SIGAR 18-01 Inspection Report

**Kabul Military Training Center Phase IV:
Poor Design and Construction, and Contractor
Noncompliance Resulted in the Potential
Waste of as Much as \$4.1 Million in Taxpayer
Funds**

**OCTOBER
2017**

Figure 1 - Configuration of the Gas Supply System for DFAC 510’s Kitchen

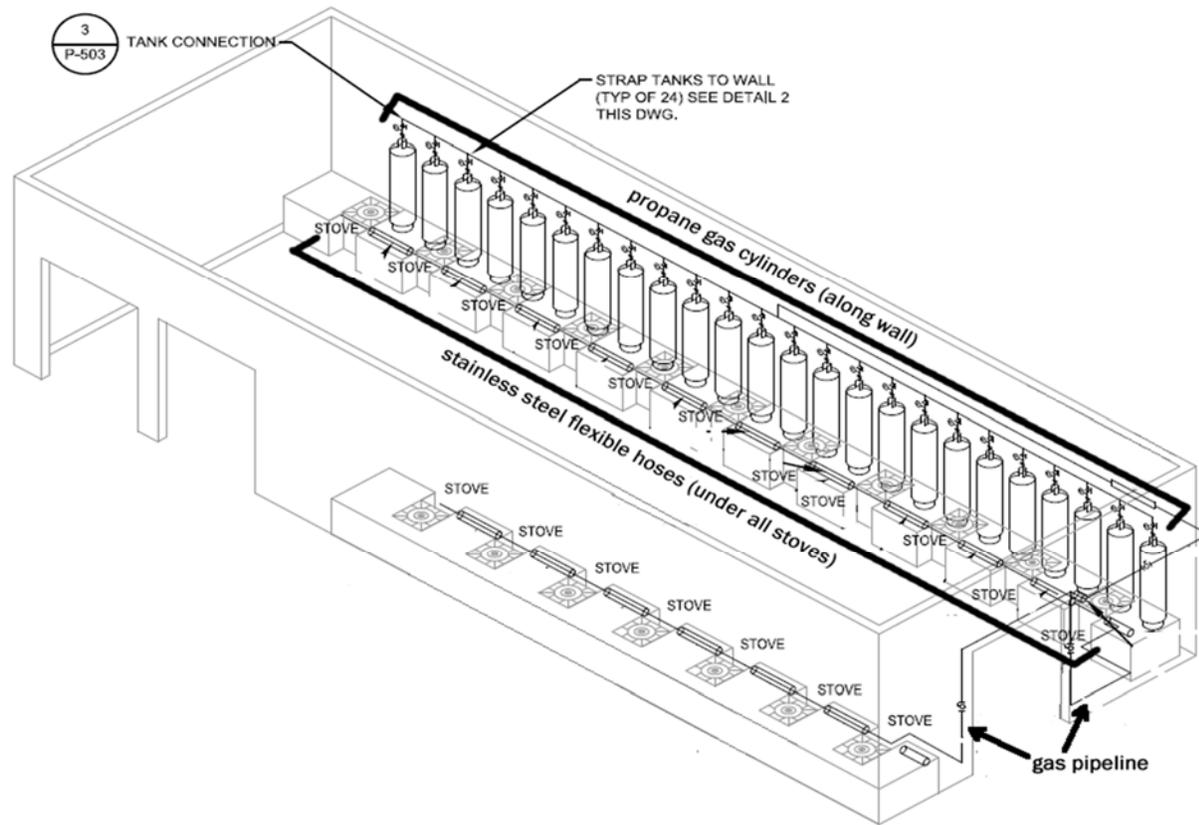
The propane cylinders that supply gas to the stoves in DFACs 510 and 511 were too close to the building. The contract required adherence to National Fire Protection Association (NFPA) standards, which specify that there be at least 10 feet of separation between propane gas cylinders and any ignition source or any building.⁷

However, USACE did not follow the NFPA standards. Specifically, USACE developed and approved technical specifications that called for “zero clearance” between the propane gas cylinders and the DFACs, which violates NFPA requirements.⁸ We found that all 54 100-pound gas cylinders—24 for DFAC 510 and 30 for DFAC 511—were located flush against the outside wall of the kitchens where gas stoves were located (see figure 1 for DFAC 510’s kitchen configuration). In addition, we found that the gas cylinder storage area contains exterior lights, which are ignition sources and could cause an explosion if gas is released. As a result, the location of these gas cylinders creates a safety hazard to kitchen workers and personnel eating in the DFACs.⁹

In March 2017, USACE told us the gas supply system’s configuration is a safety issue only if the gas cylinders rupture, thereby allowing gas to escape. USACE also told us that because the gas cylinders are outside the building, air circulation is not a problem. However, NFPA 58 does not make a distinction about whether air circulation negates the requirement for a minimum distance between a building and gas cylinders. Additionally, NFPA 58 prohibits ignition sources within 10 feet of propane gas tanks. Further, USACE did not provide us with any documentation approving a deviation from the NFPA standards or contract requirements. In July 2017, in its written comments to a draft of this report, USACE stated that placing the propane gas cylinders next to the building was a violation, and, as a result, the contract requirements did not comply with NFPA 58.

USACE concurred with recommendation 1a to relocate the propane gas cylinders at least 10 feet away from the walls of DFACs 510 and 511. USACE stated that the construction design included an error, which resulted in a code violation, and its review concluded that DFAC 510 required a separation distance of 10 feet between the tanks and the building, and DFAC 511 required a separation distance of 25 feet between the tanks and the building. USACE noted that it was performing an engineering and quality analysis to determine the best way to correct this violation, and the results would be included in its follow-up response to this report within 90 days.

Photo 2 - Stainless Steel Flexible Gas Hose with Threaded Connections on Both Ends

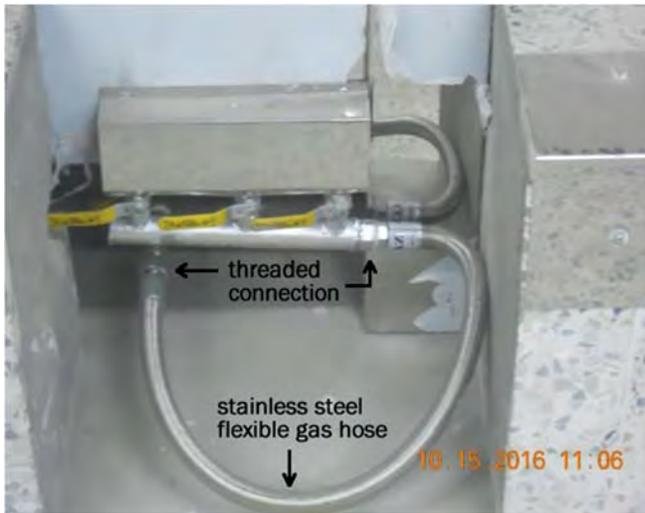
The contract's technical specifications required the gas supply line's final connection to have quick disconnect devices. They safeguard against wear and tear when the hoses need to be cleaned or repaired because they are easier to disconnect and reconnect than threaded lines.¹¹ However, we found that the gas hoses were installed with threaded connections (see photo 2). Once the hoses deteriorate, which is more likely with threaded connections, they become difficult to reattach, which can result in the threads being stripped away over time. This can lead to gas escaping from the hoses and possibly result in an explosion. In May 2017, USACE said the flexible gas hoses used in the DFACs have one end with a threaded connection and the other end with a quick disconnect device. USACE also said that this configuration allows the entire stove assembly to be removed for cleaning while keeping the threaded connection intact, thereby nullifying safety concerns. However, we found that USACE approved MegaTech's product submittal for stainless steel flexible hoses for gas lines with noncompliant threaded connections on both ends in April 2016. USACE did not provide us with any documentation showing that it approved the deviation from the approved submittal, which required the use of quick disconnect devices instead of threaded connections.

USACE did not concur with recommendation 1c to replace the threaded gas supply line's final connection to the DFAC kitchen stoves with quick disconnect devices. USACE stated that the flexible lines have one threaded end and one quick disconnect end. USACE also said it believed that the installed configuration meets safety concerns. Even though the submittal for the flexible connection hoses that USACE approved did not have a quick disconnect device, the contract required quick disconnect devices on both ends of the hoses. This recommendation will remain open until USACE provides evidence that the connections comply with the contract.

- c. replace the threaded gas supply line's final connections to the DFAC kitchen stoves with quick disconnect devices. **Non-concur.** The flexible lines have one end threaded and one end quick disconnect. SIGAR contends quick disconnects are required on both ends. In our opinion, the installed configuration meets the concerns for safety. With the one quick disconnect, the whole stove assembly can still be removed for cleaning while maintaining the threaded connection intact.

Photo 3 - Gas Line Service Valve Installed Inside DFAC 511 and Next to Electrical Disconnect Devices

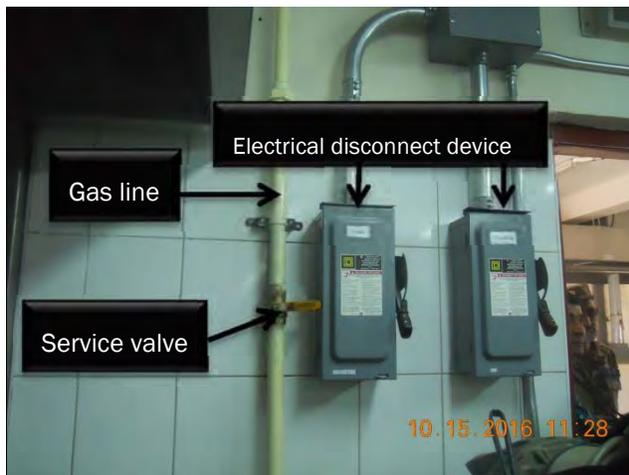
MegaTech installed the gas line service valve for DFAC 511 next to the electrical disconnect devices, which violated the design drawings, NFPA 70, and the National Electrical Code. The placement of the service valve on the gas line inside DFAC 511 and next to electrical disconnect devices creates a safety hazard. Specifically, a gas leak—especially one through the service valve—plus a spark from the electrical disconnect device could cause an explosion. USACE could not provide us with any documentation showing that it approved the deviation from the design drawings. Photo 3 shows the service valve located next to the electrical disconnect devices inside DFAC 511.¹²

that personnel can use to shut off all gas to the line when maintenance is required. The Phase IV design drawings we reviewed show that the gas line and service valves should be located so they avoid close proximity with the electrical disconnect devices. In March 2017, USACE acknowledged that the service valve could have been placed in a different location to reduce the risk of explosion. Then, in May 2017, USACE told us that

placing the gas line service valve next to electrical disconnect devices did not constitute a code violation. USACE said the gas line valve located inside the kitchen is a service valve, and the primary shut-off valve is located on the exterior of the building. However, Section 500.1 of the National Electrical Code prohibits the placement of electrical devices in close proximity to flammable gases and vapors, and it makes no distinction about the type of gas line or valve used.

USACE also took issue with our reference to NFPA 58, noting that those sections do not state that placing gas lines near electrical disconnect devices is a violation. However, NFPA 58 explicitly defers to NFPA 70 requirements for the use of electrical equipment.³⁵ NFPA 70 prohibits using electrical equipment in locations where a fire or explosion hazard may exist because of flammable gases or flammable liquid-produced vapors, which is the case in the KMTC DFACs.³⁶ Based on this, we revised our finding to refer to NFPA 70 and revised recommendation 1d to reflect that the valve adjacent to the electrical disconnect device was a service valve. This recommendation will remain open until the gas service valve is no longer next to the electrical disconnect device.

Photo 10 - Wall Opening with No Fire Stop in a Barrack

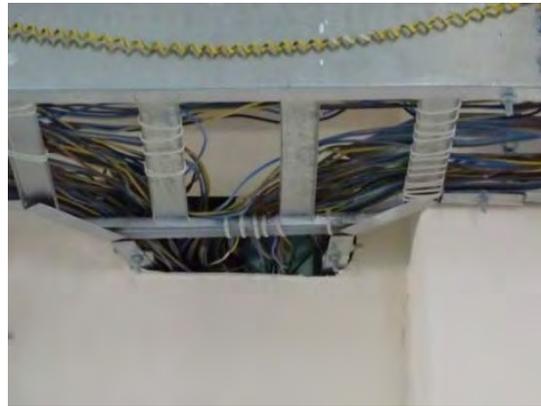
- **Fire stops.** The contract required fire stops to be used in the DFACs and barracks to form an effective barrier against the spread of flames, smoke, and gases, and to maintain the integrity of the fire-rated walls. Fire stops are used when holes are made in the walls to install wiring, air ducts, or other structures. A fire stop consists of foam, latex, or other flame-resistant materials, and it is used to fill the space in the hole so smoke and flames are less likely to travel from room to room. Photo 9 shows a compliant fire stop. We found that MegaTech did not install any fire stops in the new DFACs or barracks; photo 10 shows a wall opening in one of the barracks. In May 2017, USACE stated that the fire stop issue was under review and it was working to resolve the matter.

USACE did not concur with recommendation 1e to install emergency lighting systems and correct exit signs throughout the KMTC Phase IV facilities, and stated that it is still reviewing the fire stops issue. USACE stated that MegaTech installed emergency lighting in all cases and was allowed to install overhead lighting that had emergency back-up capability, in the form of batteries, within the fixtures. USACE also stated that because of the KMTC's voltage and power irregularities, most of the emergency lights do not function properly. USACE noted that the base does not have power 24 hours a day, and without consistent power, the batteries deplete

- e. install the fire stops and emergency lighting systems, and correct exit signs throughout the KMTC Phase IV facilities. **Non-concur on Emergency Lighting and Exit Signs; Fire Stops Require Further Review.** Emergency lighting was installed in all cases. The contractor was allowed to install overhead lighting that had emergency back-up capability integral to the fixtures. DFAC 510 showed wall mounted emergency light packs and the contractor was allowed to install integral fixtures for aesthetic and reduced maintenance. We would like to point out that due to the voltage and power irregularities at KMTC the majority of the emergency lights are not functioning properly. This was a reoccurring issue during the 4 and 9 month warranty inspections since the base does not supply power 24 hours a day. Without consistent power the battery depletes and overtime will fail.
